SCHILLINGER SOUTH PARK SUBDIVISION, **RESUBDIVISION OF LOT B**

APPLICATION NUMBER 9 DATE October 19, 2017
APPLICANT Schillinger Southpark Subdivision, Resubdivision of Lot B
REQUEST Subdivision

DETAIL SITE PLAN

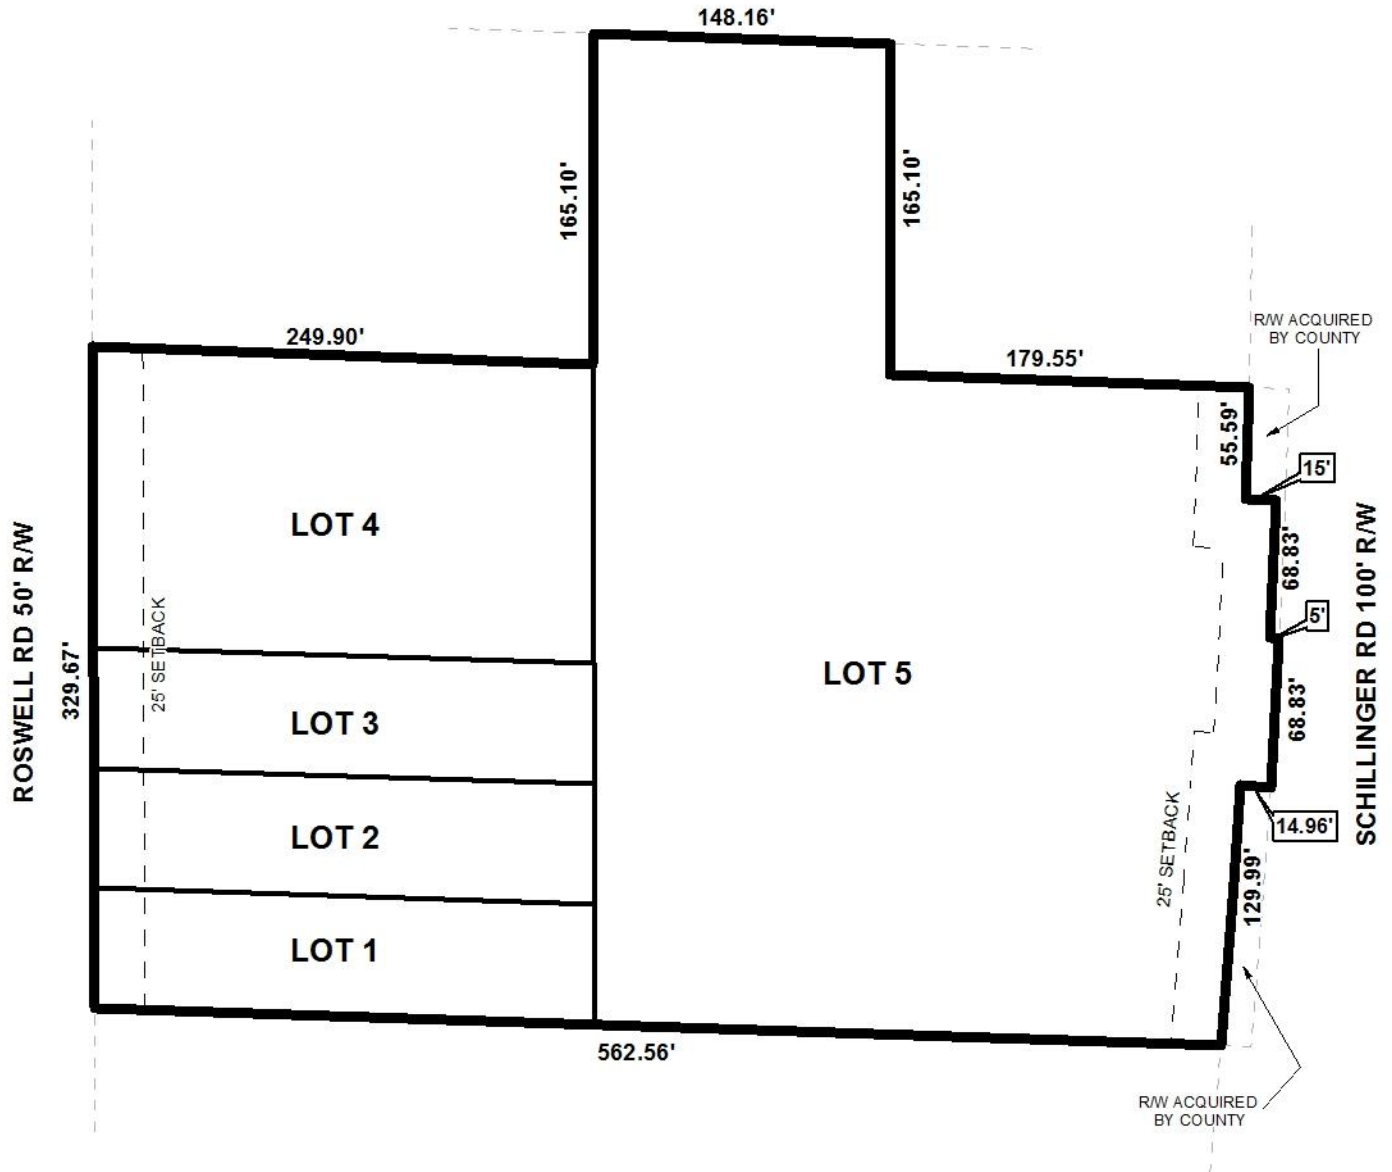
Proposed Lots 1-4 have frontage along Roswell Road South, a minor street without curb and gutter typically requiring 60' of right-of-way. The previously recorded plat for the site illustrates a 50' right-of-way, as does the preliminary plat; therefore, no additional dedication should be required.

Proposed Lot 5 has frontage along Schillinger Road South, a major street requiring 100' of right-of-way. Additional rights-of-way have been acquired by Mobile County, presumably for recent road widening projects, with the remainder of the lot's frontage reflecting adequately dedicated right-of-way. As such, no additional dedications should be required.

Lots 1-3 exceed the maximum width-to-depth ratio of Section V.D.3. of the Subdivision Regulations; therefore, a waiver of this section would be required and may be appropriate considering the Commission has approved similar lots nearby as recent as its April 18, 2002 meeting.

Lot 5 is irregularly shaped and may be considered a "flag" lot, a design discouraged by Section V.D.1. of the Subdivision Regulations unless subdivided as part of a family lot, or the result of

an innovative subdivision. While neither condition applies to the subject lot it will have 300+ feet of frontage on Schillinger Road South, thus a waiver of Section V.D.1. may be appropriate.

The lots meet the minimum size requirements for lots served by a public water supply and private septic systems, and are appropriately labeled on the preliminary plat in square feet and acres. This information should be retained on the Final Plat, if approved; or, provision of a table on the Final Plat providing the same information may suffice.

The 25' minimum building setback line required by Section V.D.9. of the Subdivision Regulations is illustrated on the preliminary plat for all proposed lots and should be retained on the Final Plat, if approved.

With regards to access management, a note should be required on the Final Plat stating that Lots 1-4 are each limited to one (1) curb cut to Roswell Road South, and that Lot 5 is limited to two (2) curb cuts to Schillinger Road South, with any changes to their sizes, locations or designs to be approved by Mobile County Engineering and conform to AASHTO standards.

This site is located in the County, thus any lots which are developed commercially and adjoin residentially developed property must provide a buffer in compliance with Section V.A.8. of the Subdivision Regulations. A note regarding this requirement should appear on the Final Plat, if approved.

It should be noted that proposed Lot 4 is developed with what appears to be a single-family residence.

With waivers of Sections V.D.1. and V.D.3. the proposed plat meets the minimum requirements of the Subdivision Regulations and is recommended for Tentative Approval, subject to the following conditions:

- 1) retention of the lot sizes in square feet and acres on the Final Plat, or the provision of a table on the Final Plat providing the same information;
- 2) retention of the 25' minimum building setback line on the Final Plat;
- 3) placement of a note on the Final Plat stating that Lots 1-4 are each limited to one (1) curb cut to Roswell Road South, and that Lot 5 is limited to two (2) curb cuts to Schillinger Road South, with any changes to their sizes, locations or designs to be approved by Mobile County Engineering and conform to AASHTO standards;

- 4) placement of a note on the Final Plat stating lots which are developed commercially and adjoin residentially developed property must provide a buffer, in compliance with Section V.A.8. of the Subdivision Regulations;

- 5) placement of a note on the Final Plat to comply with the Mobile County storm water and flood control ordinances: *“Must comply with the Mobile County Flood Damage Prevention Ordinance. Development shall be designed to comply with the storm water detention and drainage facility requirements of the City of Mobile storm water and flood control ordinances, and requiring submission of certification from a licensed engineer certifying that the design complies with the storm water detention and drainage facility requirements of the City of Mobile storm water and flood control ordinances prior to the issuance of any permits.”*; and,

- 6) compliance with Fire Department comments: *“Projects outside the City Limits of Mobile, yet within the Planning Commission Jurisdiction fall under the State or County Fire Code (2012 IFC.)”*
